FACTSHEET

TITLE: **SPECIAL PERMIT NO. 09029, the Heritage Lakes Drive Multi-Family Community Unit Plan,** requested by Continental Properties, on property generally located northeast of the intersection of South 91st Street and Heritage Lakes Drive.

LINCOLN CITY/LANCASTER COUNTY PLANNING STAFF REPORT

PROJECT #: Change of Zone #09030 - From R-3 to R-5
Special Permit #09029 - Heritage Lakes Drive Multi-Family Community Unit Plan (CUP)

COVER SHEET

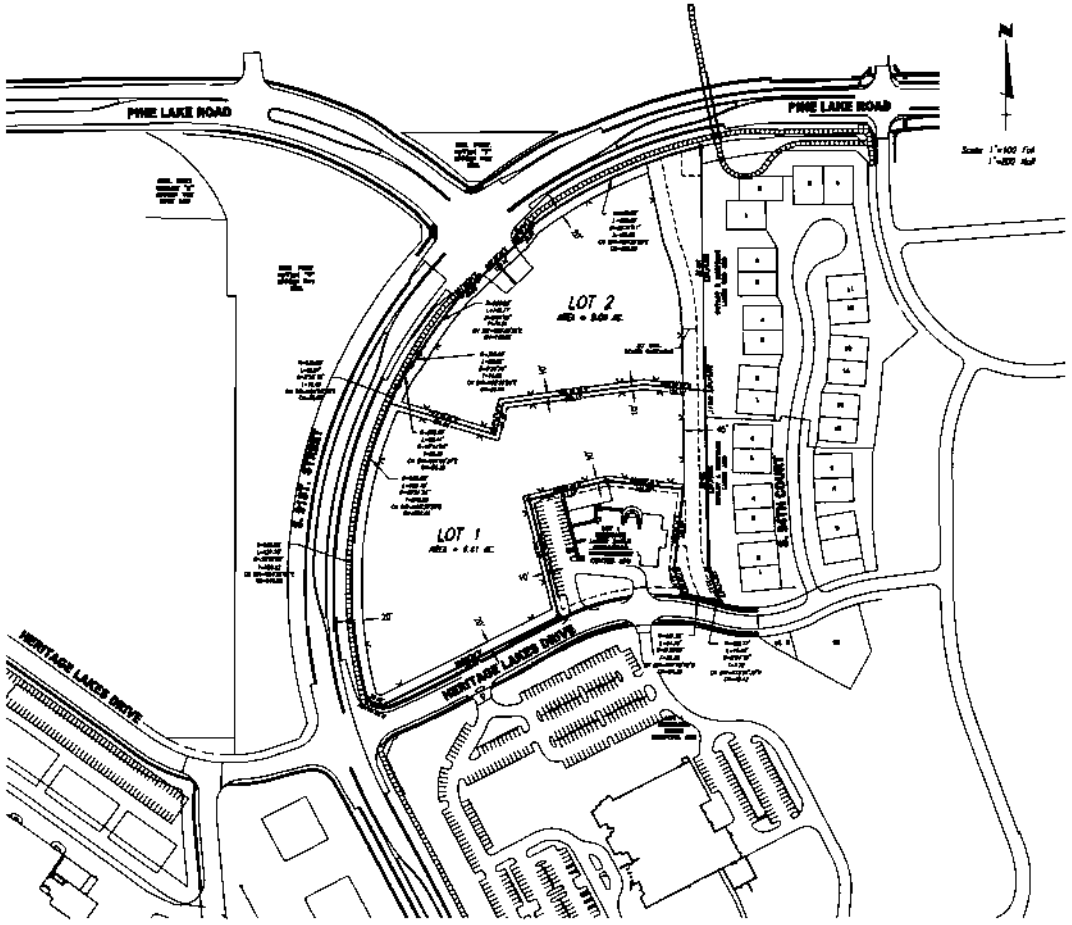
2.1 Consolidate all general notes from Sheets 1, 4 and 5 onto one sheet.

2.3 Delete the labels on Sheet 4 identifying 'Proposed Heritage Lakes Drive Signage', and revise General Note #11 on Sheet 1 to state "SIGNS NEED NOT BE SHOWN ON THIS PLAN AND TO BE REVIEWED AT THE TIME OF SIGN PERMIT IN COMPLIANCE WITH LMC AND DESIGN STANDARDS EXCEPT AS ADJUSTED BY THIS SPECIAL PERMIT. IF LOT 2 IS DEVELOPED AS AN EXPANSION OF LOT 1, ONLY ONE SIGN SHALL BE ALLOWED AT THE DRIVE ENTRANCE AT THE INTERSECTION OF SOUTH 91ST STREET AND PINE LAKE ROAD."

2.5 Revise the 'Waivers' statement on Sheet 1 to include: A-Waiver to required parking from 2 to 1.75 spaces per unit and the required space for the leasing office; B-Waiver to sign requirements to allow signs in alternate locations; C-Waiver to paving thickness as approved by Public Works.

2.6 Eliminate references to 'Use Permit' on Sheet 1, and substitute the name of the development for the applicant's name on all sheets.

2.7 Identify and show the approximate location of the common access easement across Lot 2 on both sheets 1 and 4, and add a label noting that a common access easement is granted across Lots 1 and 2.

2.13 Delete General Notes 3 and 10 on Sheet 1.

SHEET 4 OF 5

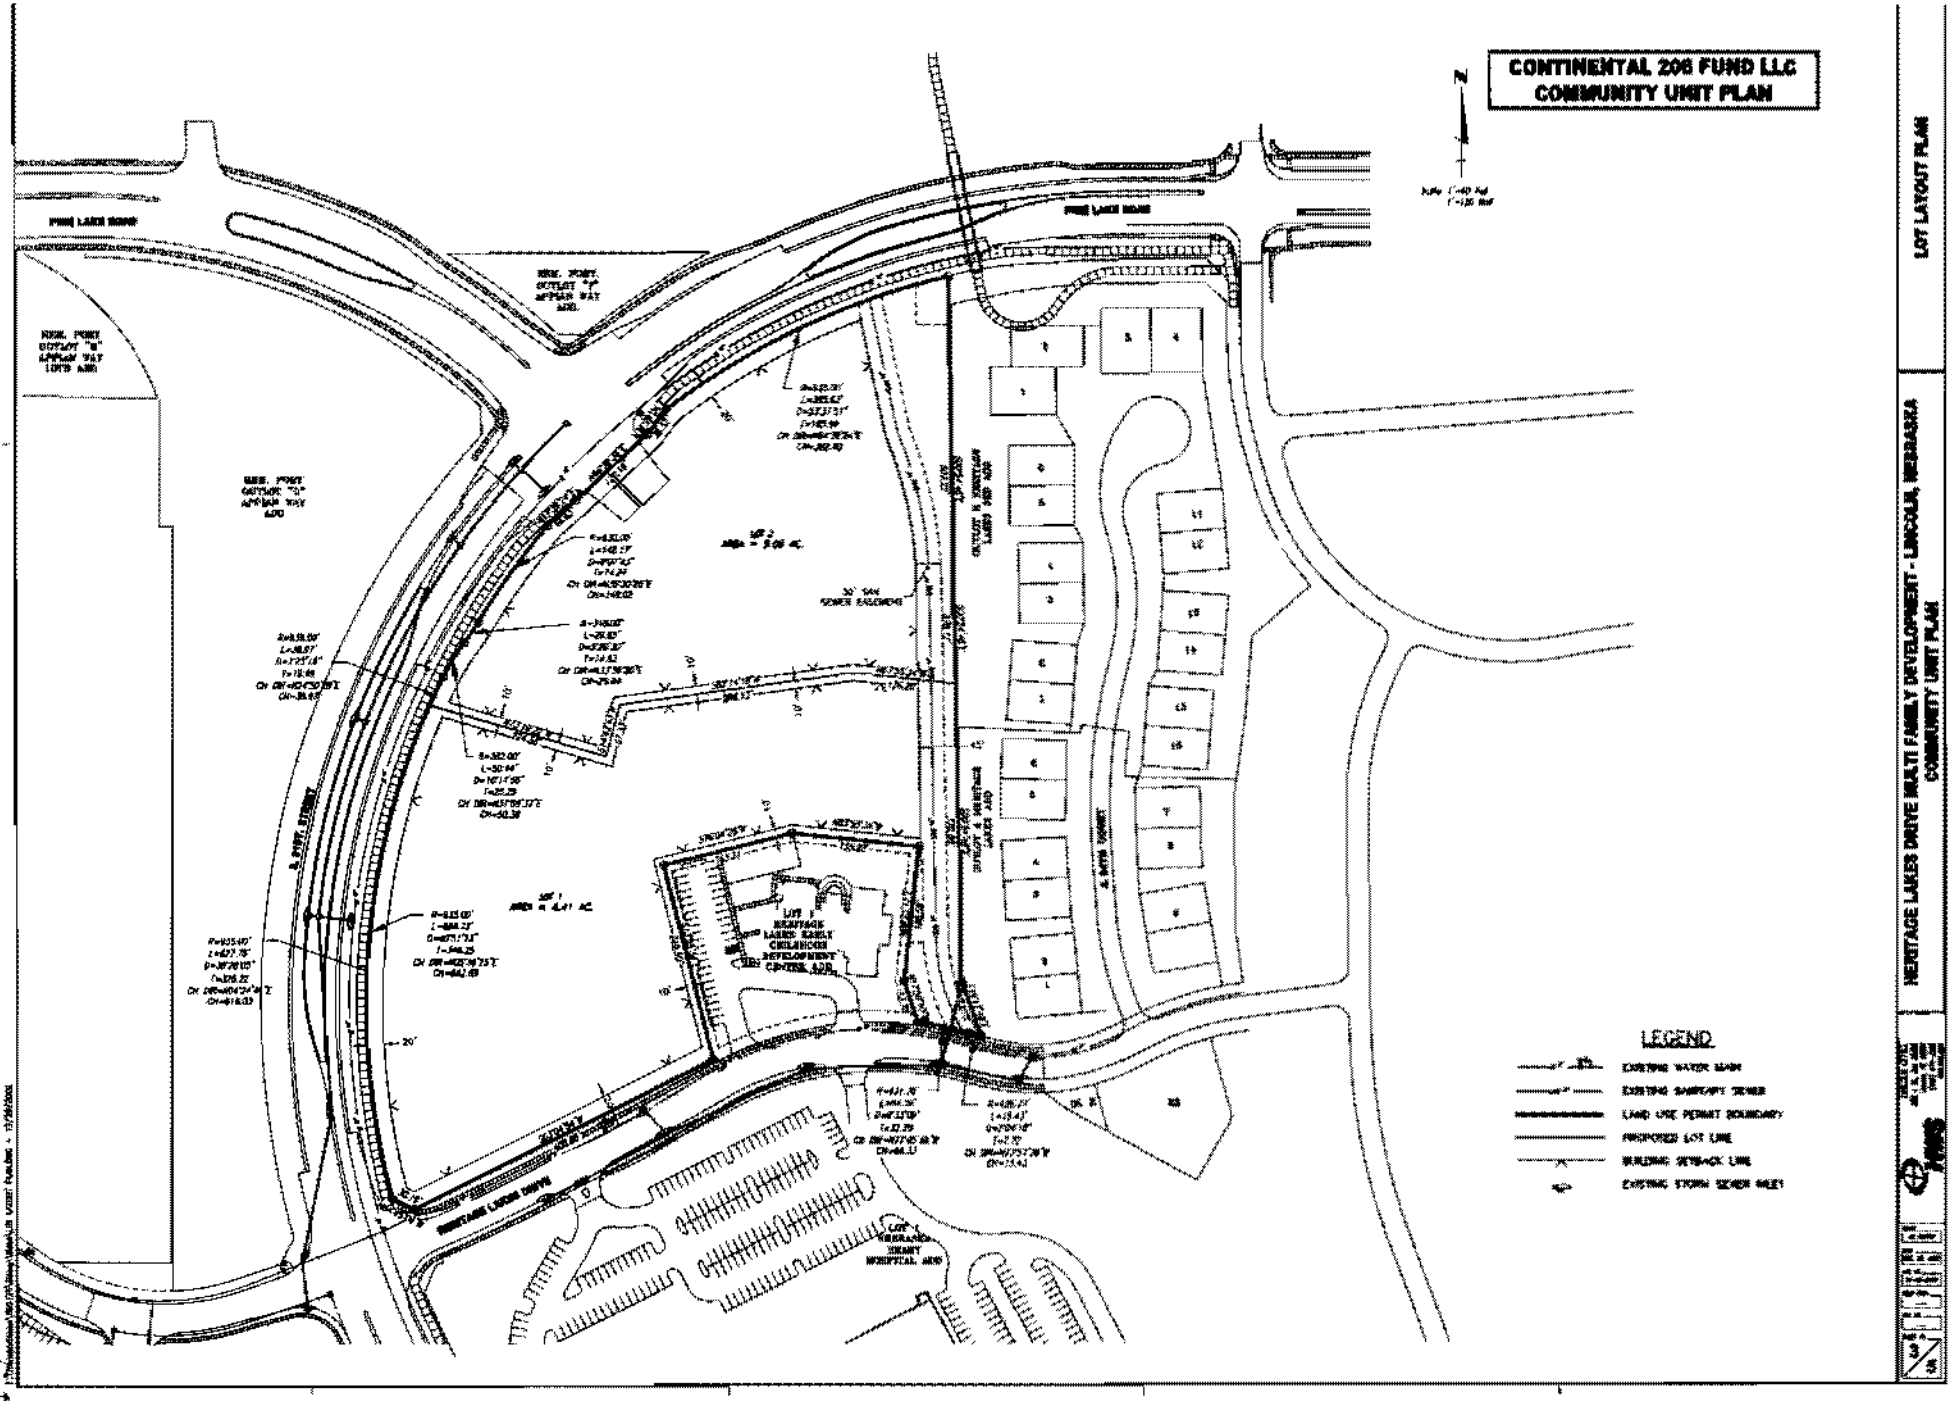
2.2 Label all setbacks on Sheet 4 as front, side or rear as appropriate.

2.9 Delete the parking summary and site design tables on Sheet 4 and add a general note that states 'PARKING SHALL BE PROVIDED IN COMPLIANCE WITH LMC AND DESIGN STANDARDS AT THE TIME OF BUILDING PERMIT EXCEPT AS ADJUSTED BY THIS SPECIAL PERMIT."

2.18 Eliminate the curb and gutter plan from Sheet 4.
